Eagle Ranch Association
Regular Meeting
Design Review Board

MINUTES OF A MEETING OF
THE DESIGN REVIEW BOARD OF
EAGLE RANCH ASSOCIATION

Design Review Memorandum

Project Number: 25-00-64
Owner Name: Jill and Collier Pennington
Architect: Brennen Fitzgerald – Scott Turnipseed AIA
Address: 1880 E Haystacker Dr
Legal: EAGLE RANCH FILING 25 Lot: 64
Preliminary DRB Meeting Date: April 18, 2024

1 NORTH EXTERIOR ELEVATION
 A3.1 1/4" = 1'-0"
 NOTE: REFERENCE SHEET A5.2 FOR WINDOW SCHEDULE

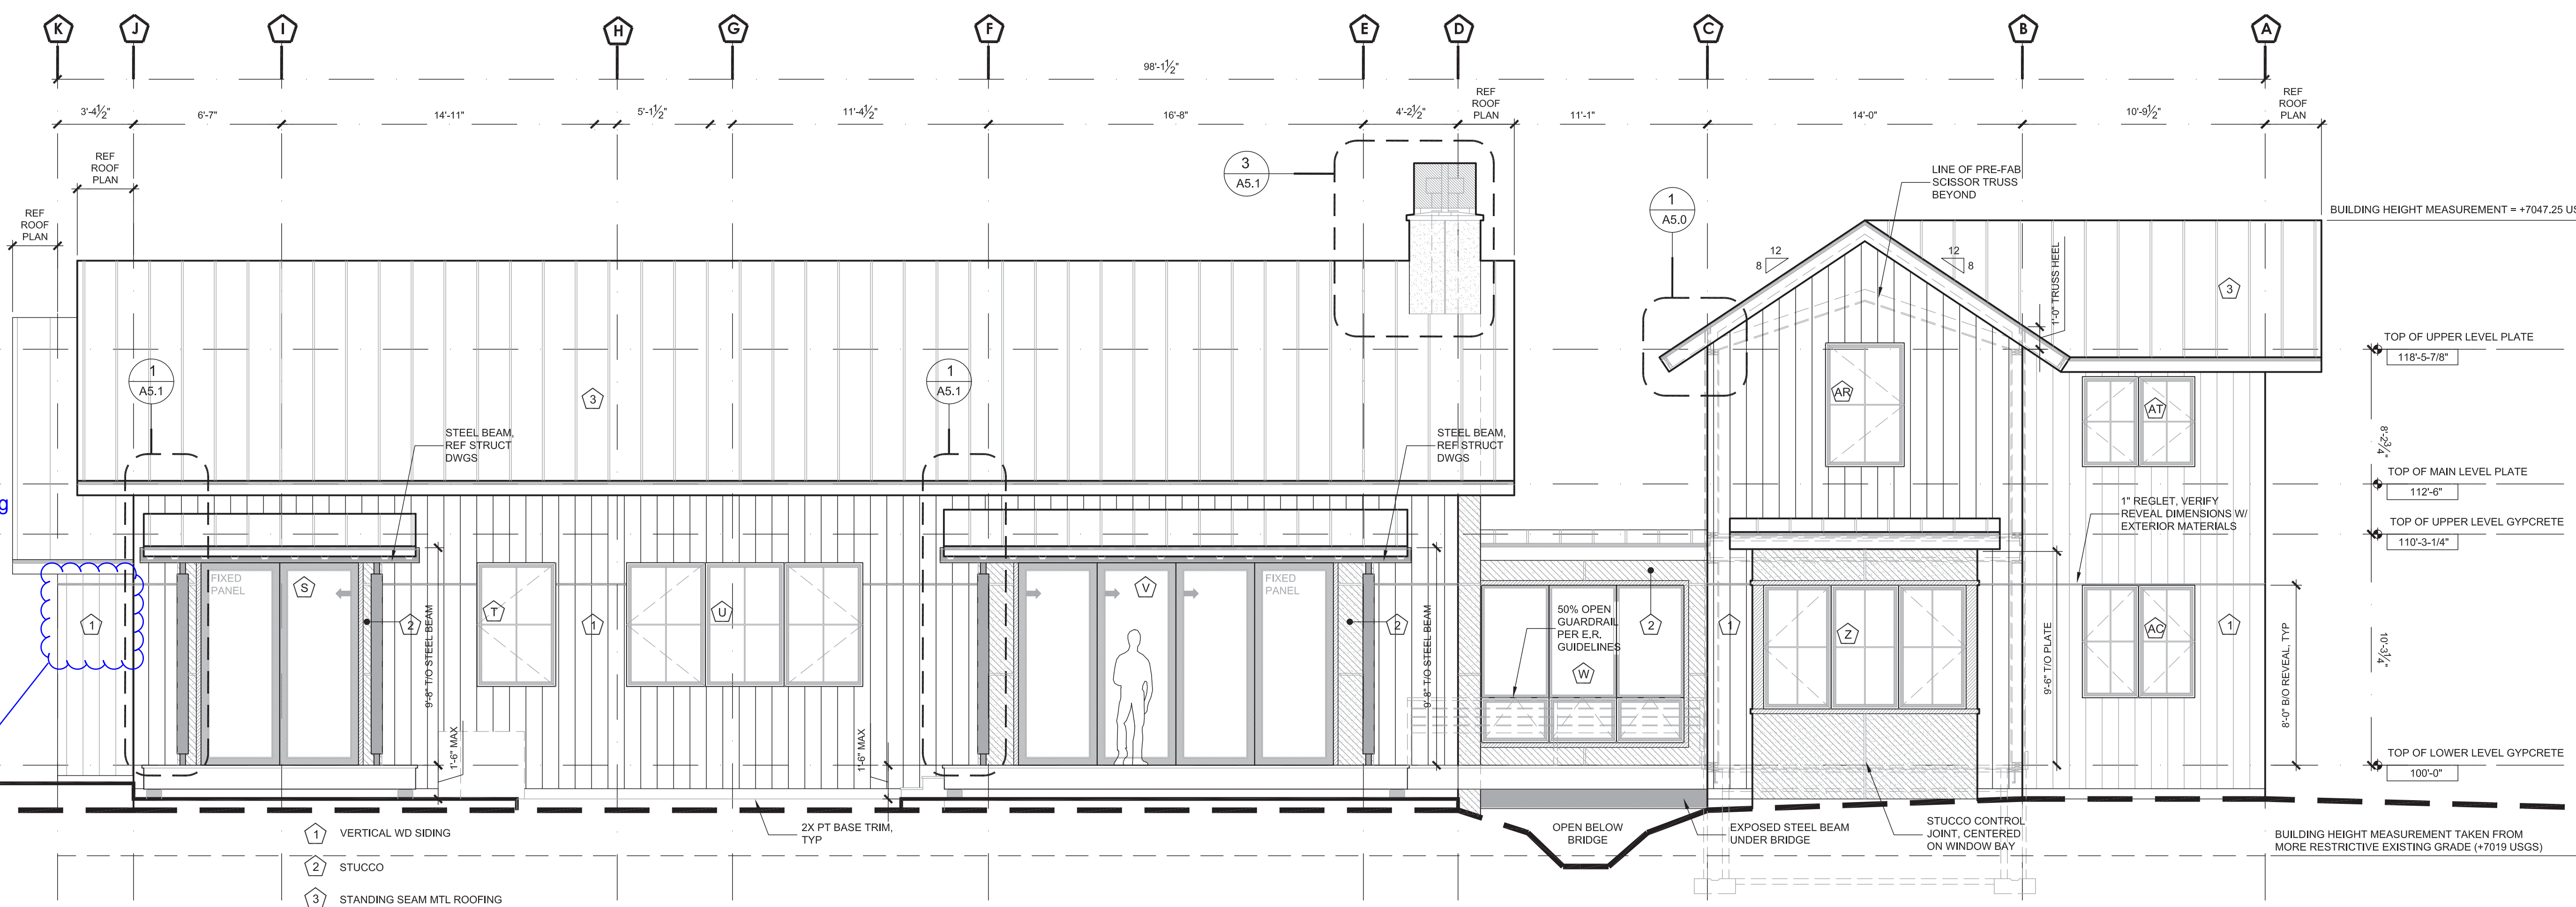
Show exterior lighting fixtures on elevations.

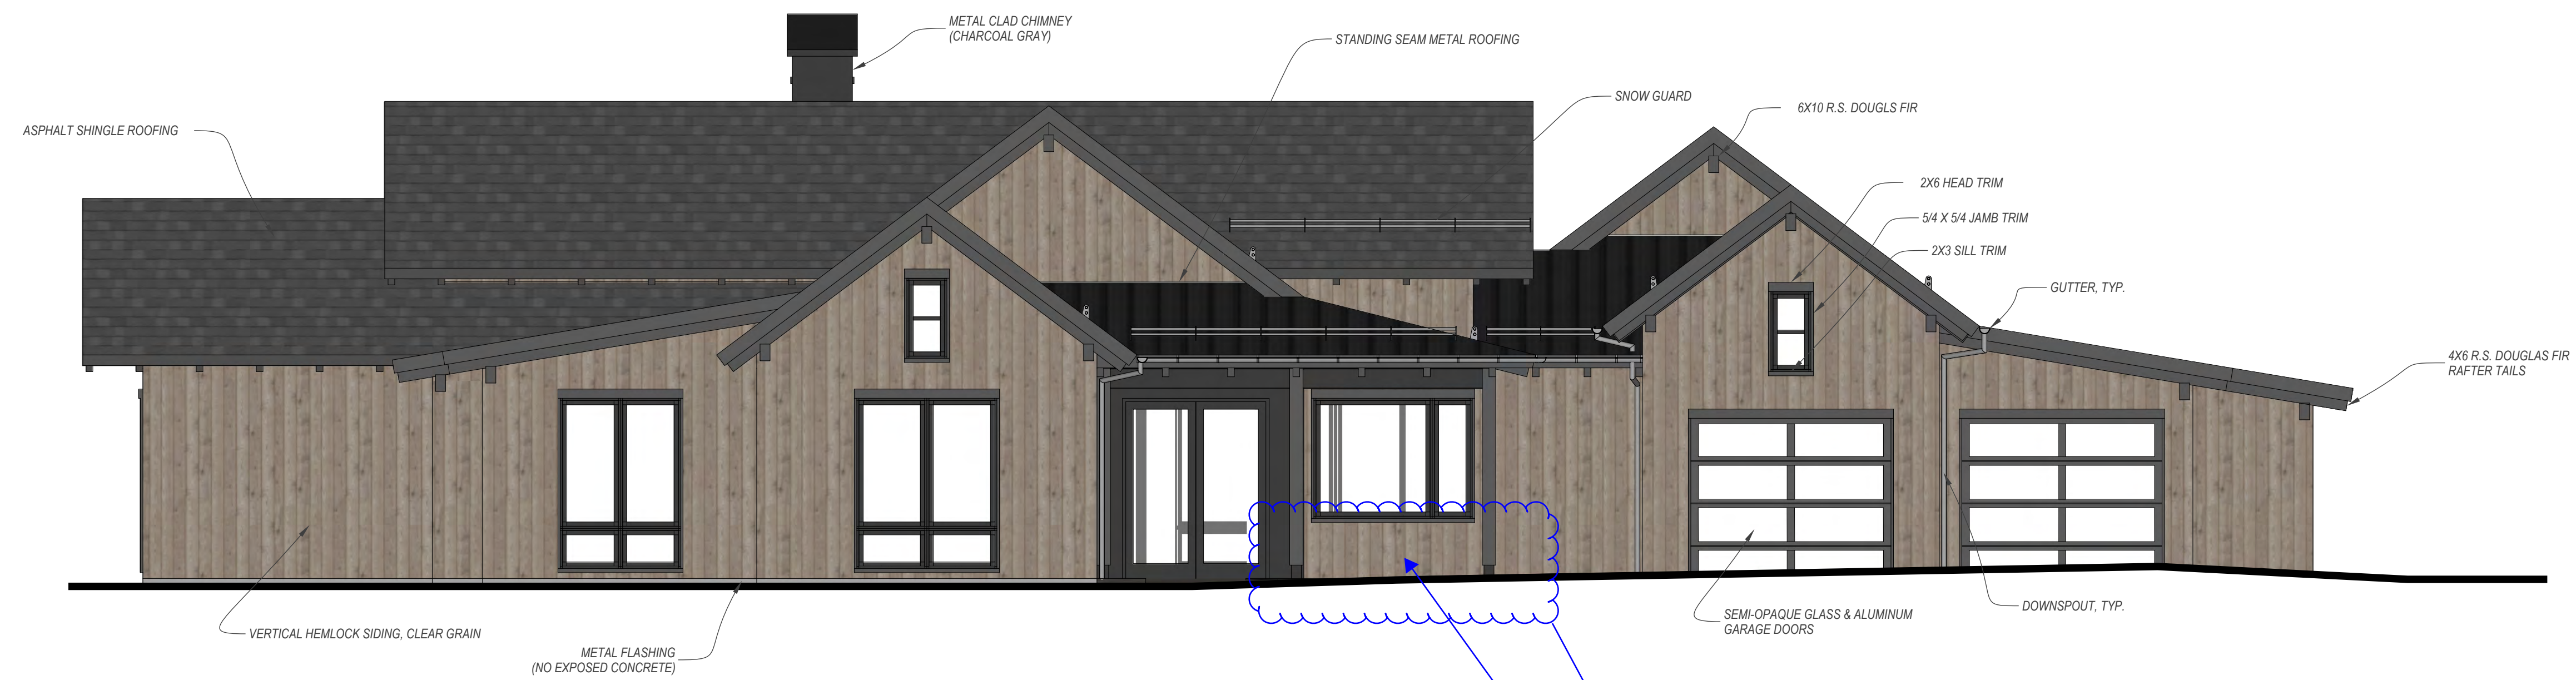
2.3.2.3 (5): Except for selected large fixed glass picture windows, all casement and fixed glass windows require one of the following divided light patterns:
